## CLEVELAND NATIONAL FOREST POWER LINE REPLACEMENT PROJECTS

### MINOR PROJECT REFINEMENT REQUEST FORM

<b>Date Submitted:</b>	03-29-18	<b>Request #:</b>	016
<b>Date Approval Required:</b>	04-02-18	<b>Landowner:</b>	Various
<b>APN:</b>	XXX-XXX-XX, XXX-XXX-XX, XXX-XXX-XX		
<b>Refinement from (check all that apply):</b>			
<input type="checkbox"/> Mitigation Measure	<input type="checkbox"/> APM	<input checked="" type="checkbox"/> Project Description	<input type="checkbox"/> Drawing <span style="margin-left: 20px;"><input checked="" type="checkbox"/> Other</span>
<b>Identify source (mitigation measure, project description, etc.):</b>			
<p>Notice to Proceed (NTP) request #1 for the rebuild of Transmission Line (TL) 625B and TL629E was approved by the California Public Utilities Commission (CPUC) and United States Forest Service (USFS) on September 21, 2016. The subsequent Minor Project Refinement (MPR) request #2 for changes associated with TL625B and TL629E was approved by both agencies on February 10, 2017. Since the approvals, San Diego Gas &amp; Electric Company (SDG&amp;E) has made revisions to the scope of work included in NTP request #1 and MPR request #2. A description and ju

**Attachment B:  
Comparison Map  
TL629E Map 1 of 1**

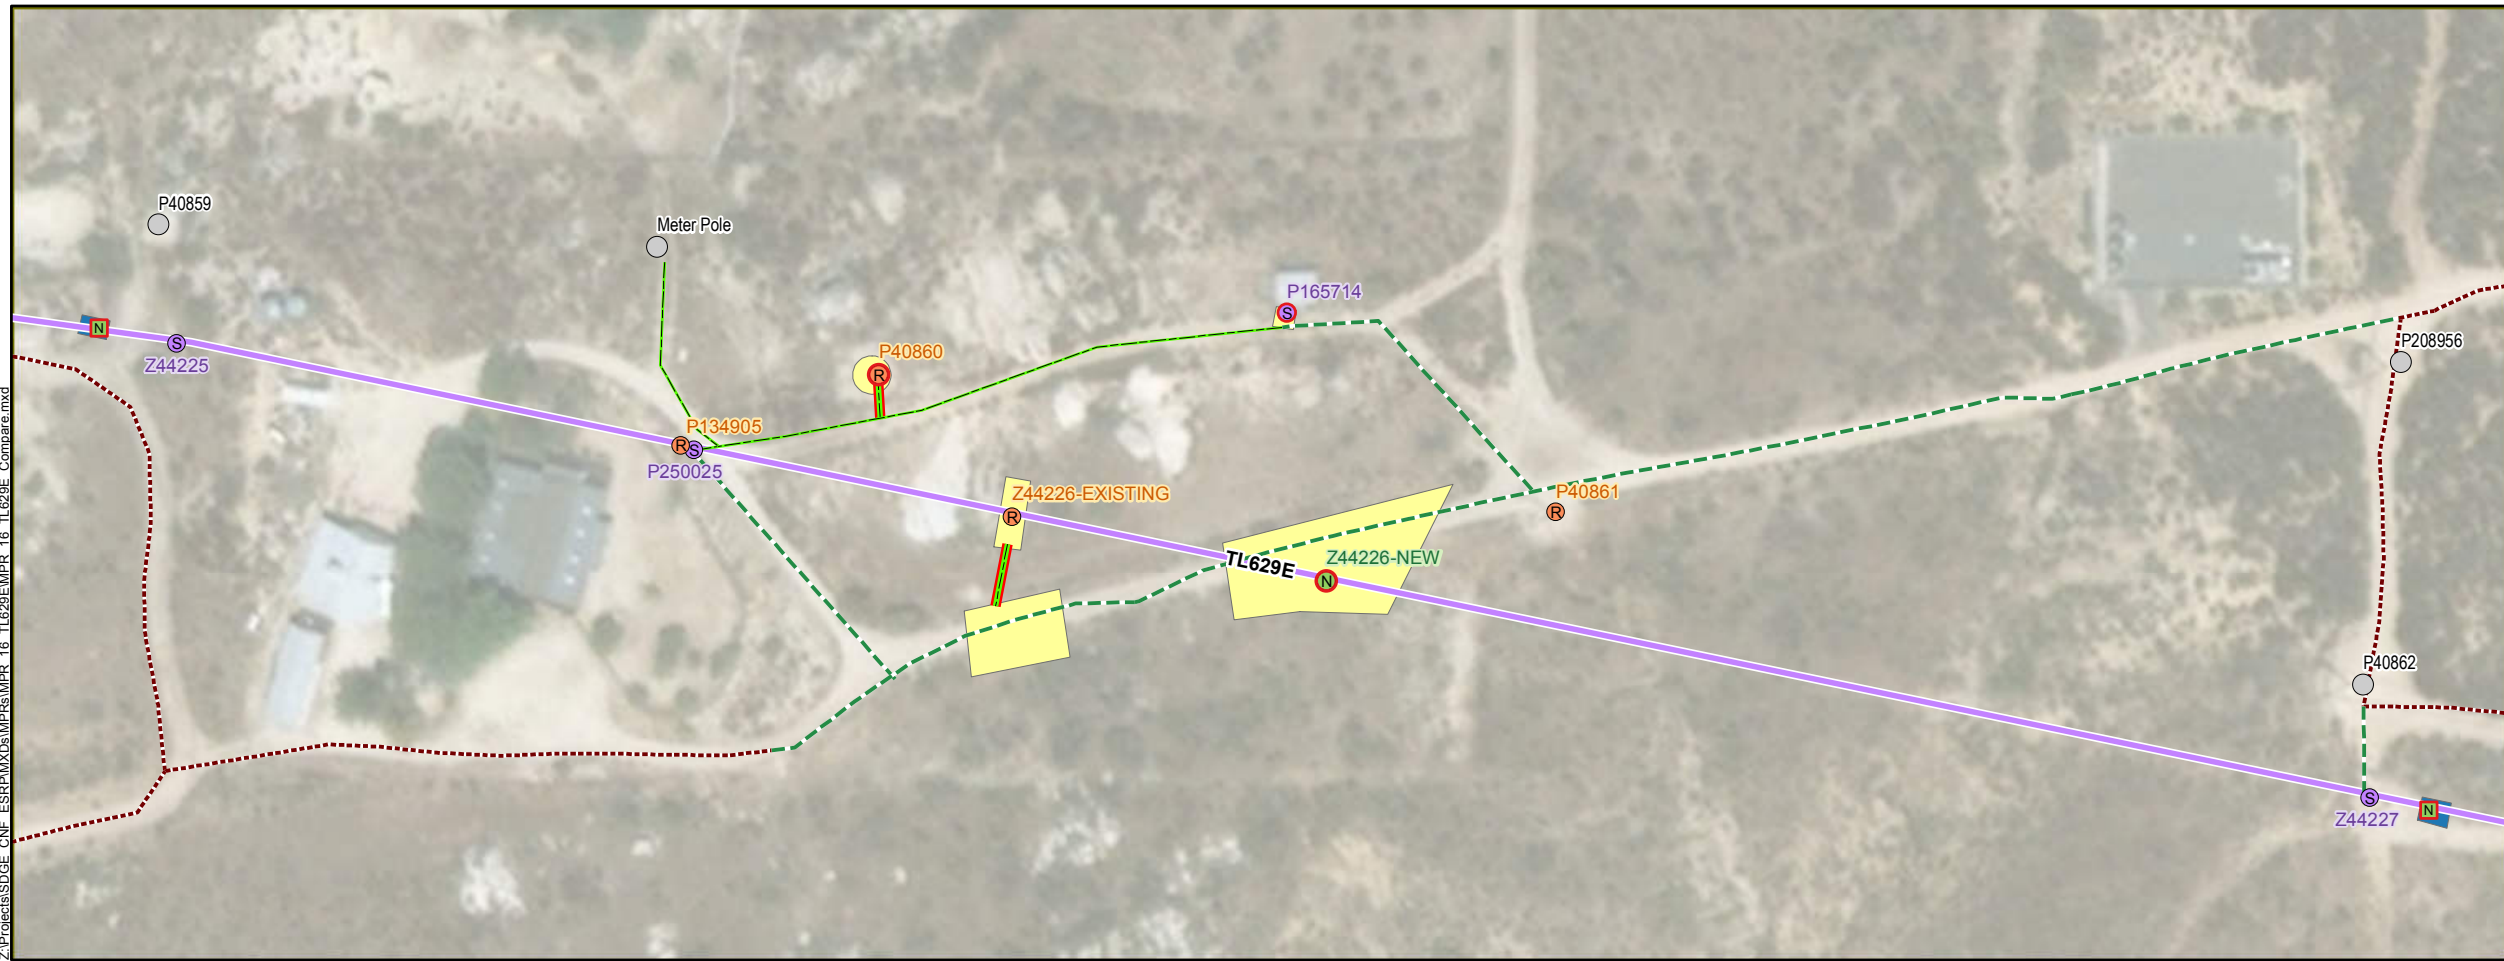
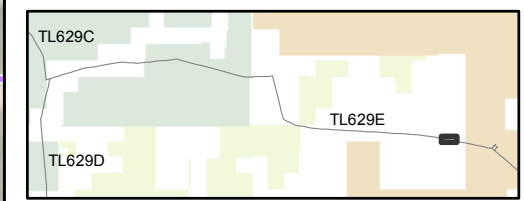
- addition of two anchors and the associated anchor work areas;
- addition of approximately 30 feet of footpath to the existing location for Pole Z44226;
- relocation of the new Pole Z44226 approximately 160 feet southeast and a pole height increase of approximately 22 feet, as well as reconfiguration of the temporary pole work areas at the new pole location and the removal pole location;
- addition of a temporary pole work area and footpath for the removal of Pole P40860;
- conditional release of work<sup>1</sup> at Poles P40860 and P165714; and
- relocation of AT&T facilities from parallel distribution structures to between Poles Z44225 and Z44227.

Attachment B: Comparison Map depicts the facilities and workspaces requested and/or approved in NTP #1 and MPR #2 in comparison to the requested refinements, as described in this MPR request. Table 1: NTP #1, MPR #2, and MPR #16 Crosswalk includes more information on which NTP/MPR requested the facilities, their approval status, and the work proposed for those facilities in this MPR. The requested refinements will result in an increase of up to 0.17 acre of temporary impacts (of which approximately 0.07 acre is classified as native vegetation) and less than 0.01 acre of permanent impacts.<sup>2</sup> The breakdown of the temporary and permanent impacts is summarized in Attachment C: Impacts Table. The activities associated with the construction and utilization of the refinement areas will occur in the same manner as described in the Final EIR/EIS for construction of the Project. In addition, the scope of work at Pole Z44226 and associated structures is described in more detail in the following subsections and will occur in accordance with SDG&E's Cultural Resources Letter Report dated March 19, 2018.
